PLANNING AND DEVELOPMENT SERVICES STAFF REPORT

For Planning Commission Meeting of January 15, 2013

**SUBJECT: 624 Church Street Site Plan for City Council Approval
(624 Church Street)
Project No. SP12-035**

624 Church Street Summary Report

624 Church Street
Ann Arbor, MI
FIRST FLOOR PLAN
w/ SITE

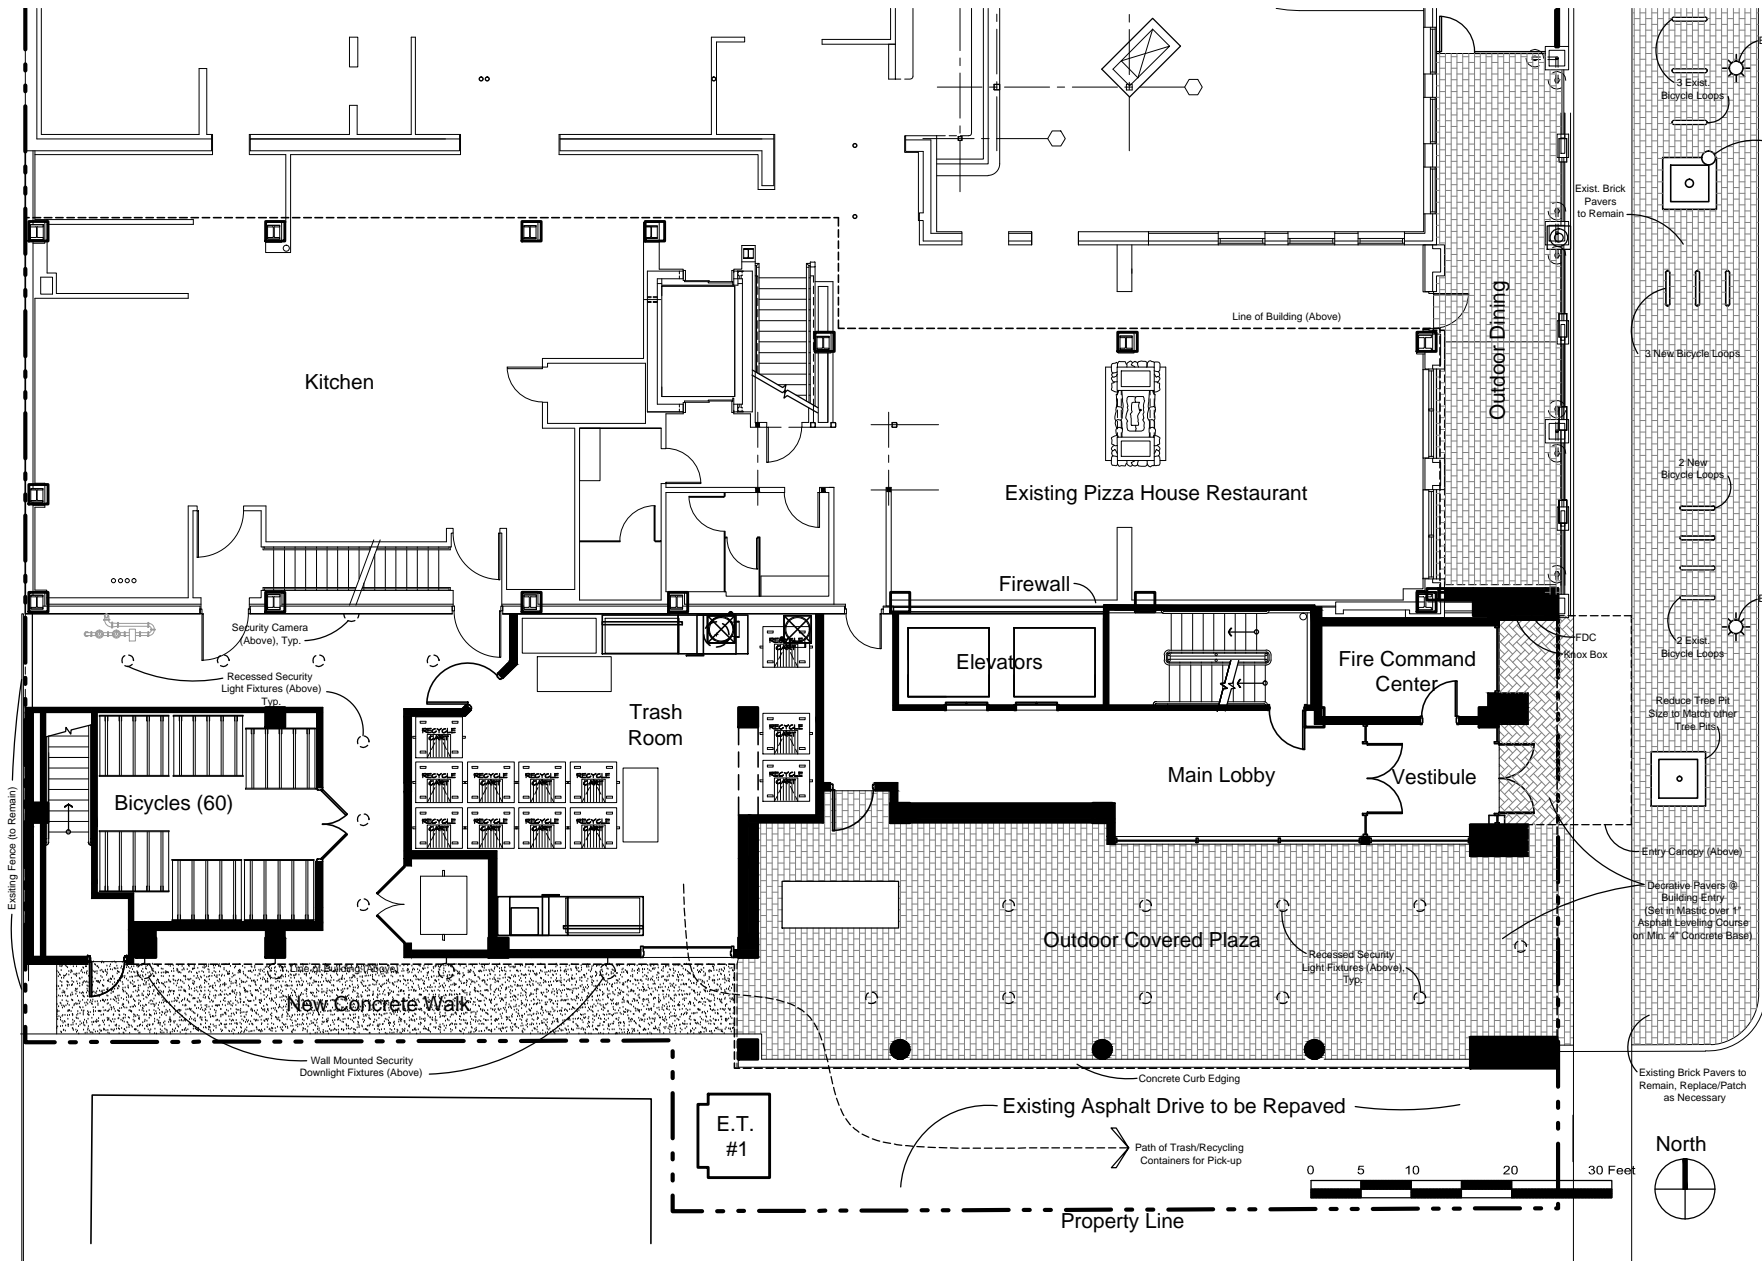
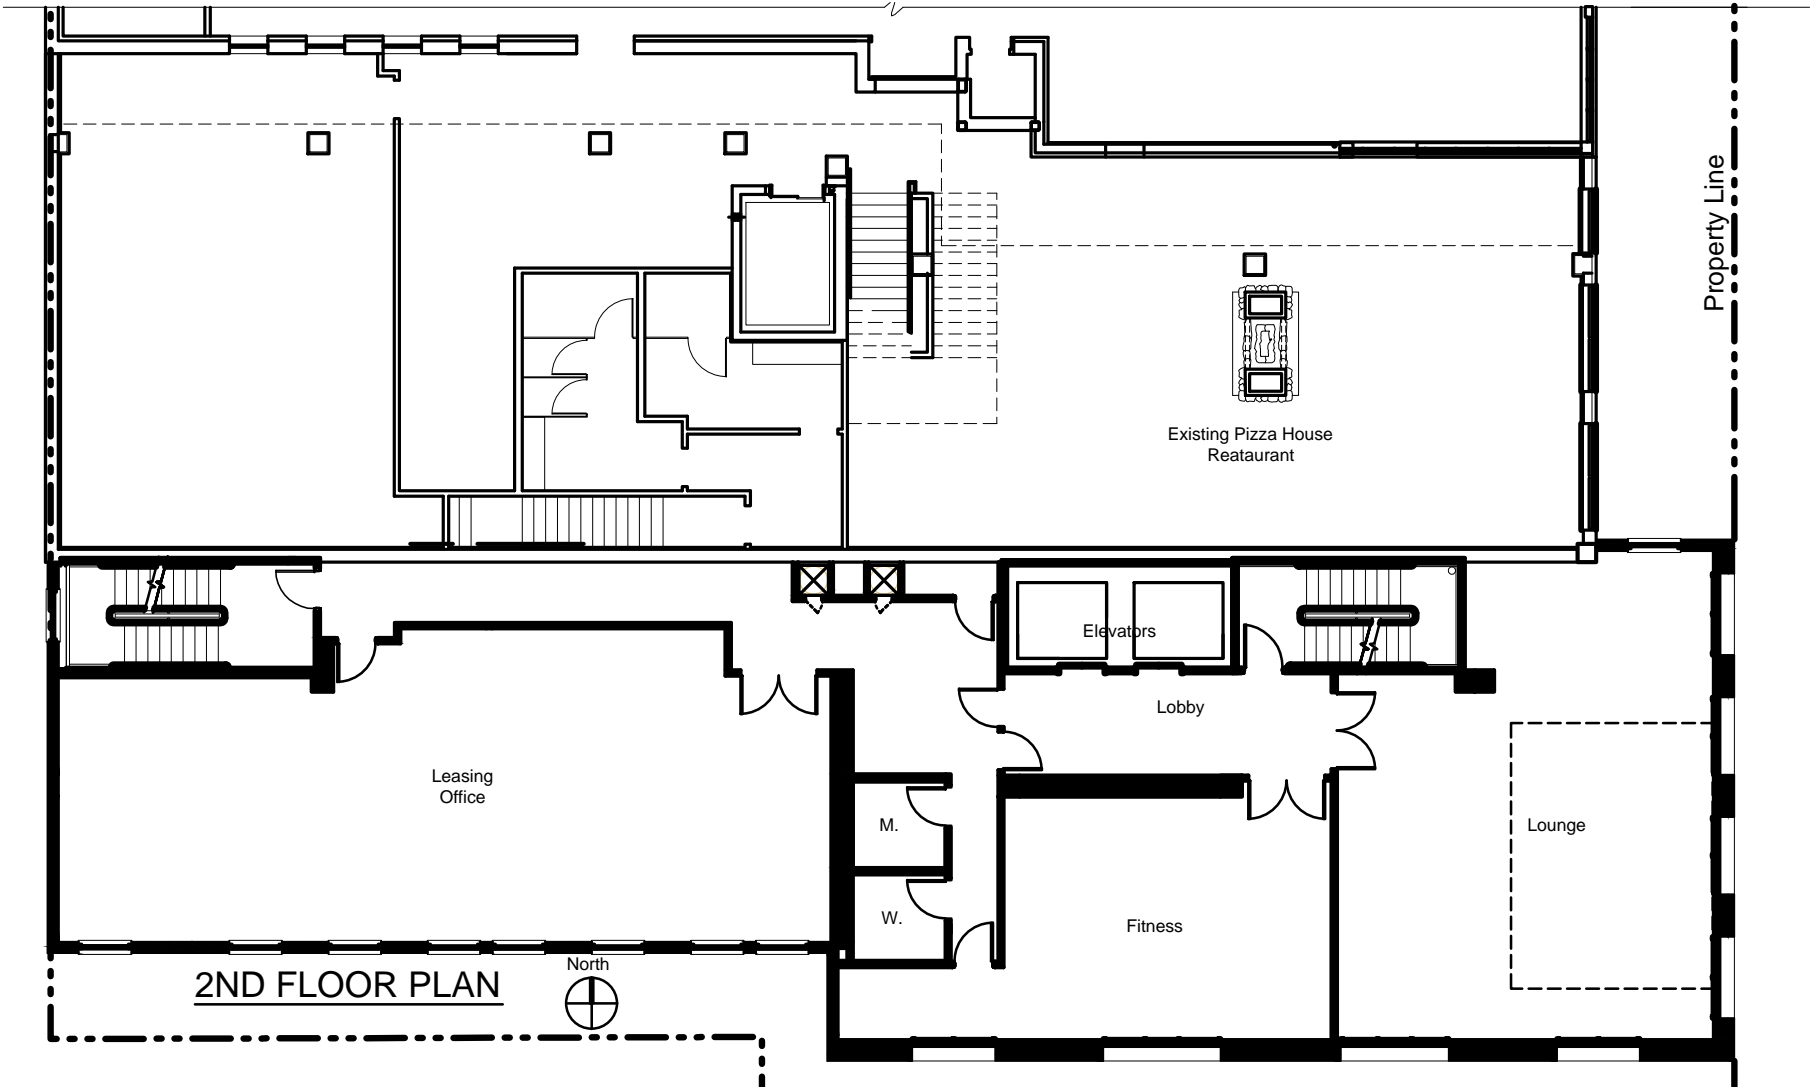
Revised plans will need to be submitted that show curb cut dimensions and all walkable portions of the sidewalk constructed of concrete, not decorative pavers.

As the drive for the loading zone is shared with an adjacent parcel, this will require a recorded easement to guarantee future access. The placement of bicycle hoops in the public right of way may require an additional agreement.

Revisions are needed to the grading plan to ensure proper site drainage and clarifications to the storm water management system calculations before site plan approval by City Council.

EAST ELEVATION
 SCALE: 1/8"=1'-0"

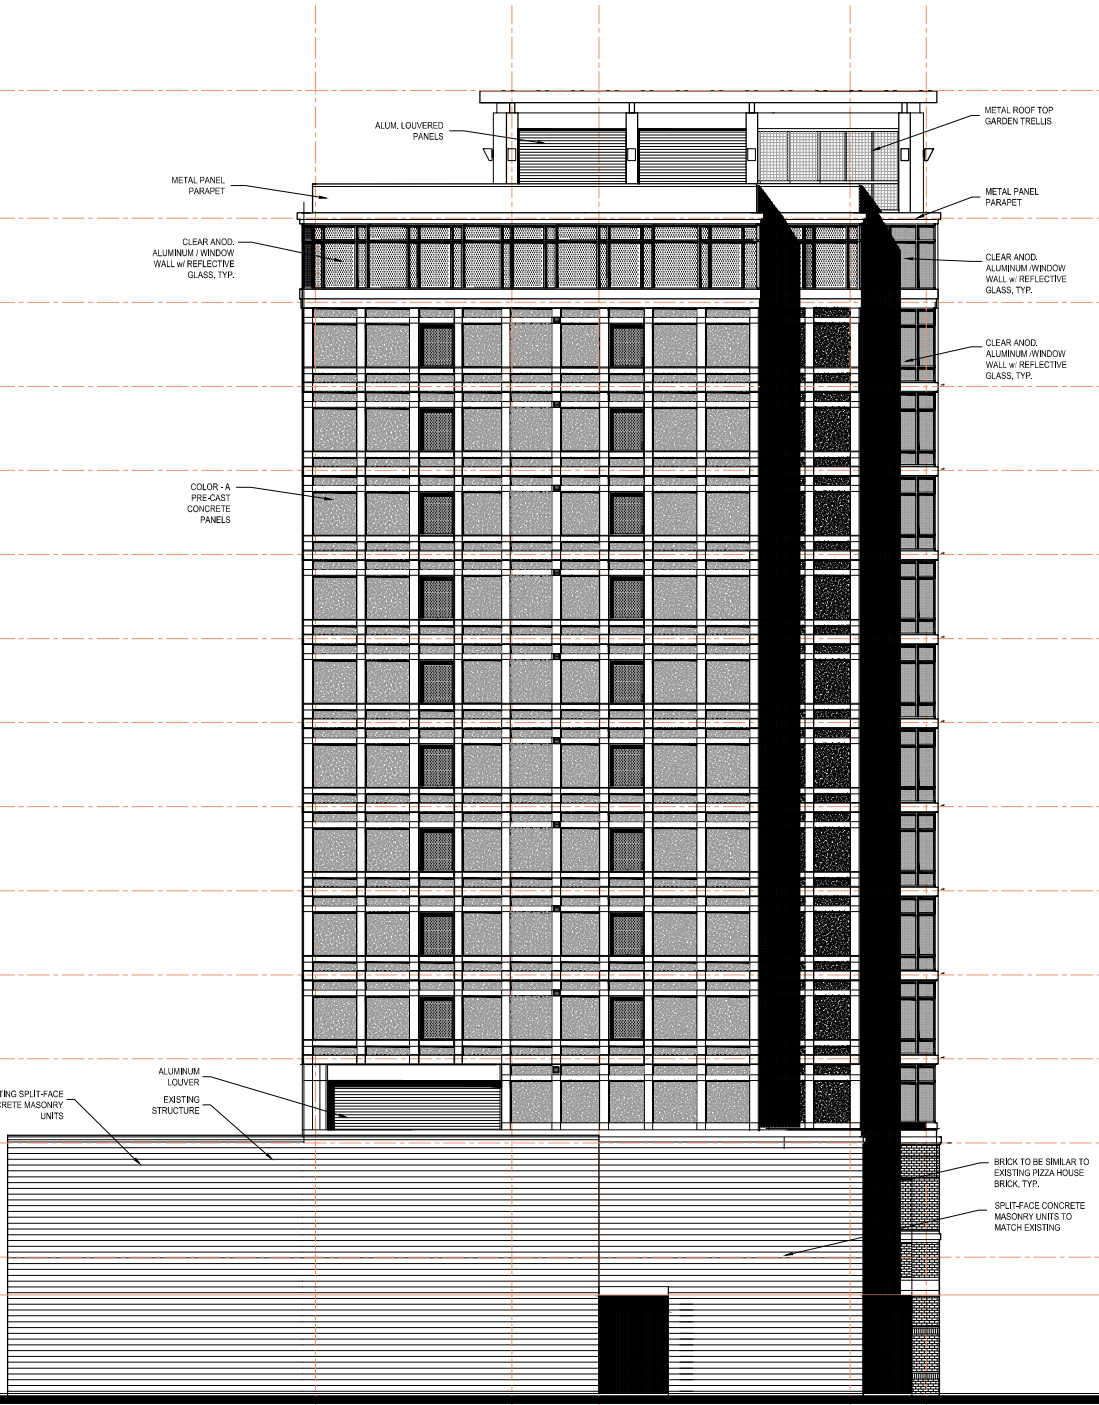
1. Use changes in building volumes rather than simply changing building materials that exist in the same plane to express massing and height of building modules. The use of brick is encouraged at locations where scaffolding would be possible. (See Guideline B.1.2)

2. If the heating and air conditioning design is changed and the grilles are removed from the southeast building face, the articulated panel/grill areas should be kept; flat panels in this location will detract from the design (see Guideline B.1.2)

The Board raised questions about how the tower façade would be redesigned if the HVAC grillwork was no longer needed as a result of a change to heat pump. Moore said that they would fill in the openings, but keep the change in surface. The Board encouraged the articulated panel/grill areas to be kept, since flat panels in this location will detract from the design.

1. Use changes in building volumes rather than simply changing building materials that exist in the same plane to express massing and height of building modules. The use of brick is encouraged at locations where scaffolding would be possible. (See Guideline B.1.2) ***Offsets in the building walls are coordinated with material and color changes to break up building massing. Texturing will be incorporated in the precast panels above the second floor which may include some brick or incorporating brick form liners in the precast panels. Brick will be used on the second and first floor.***
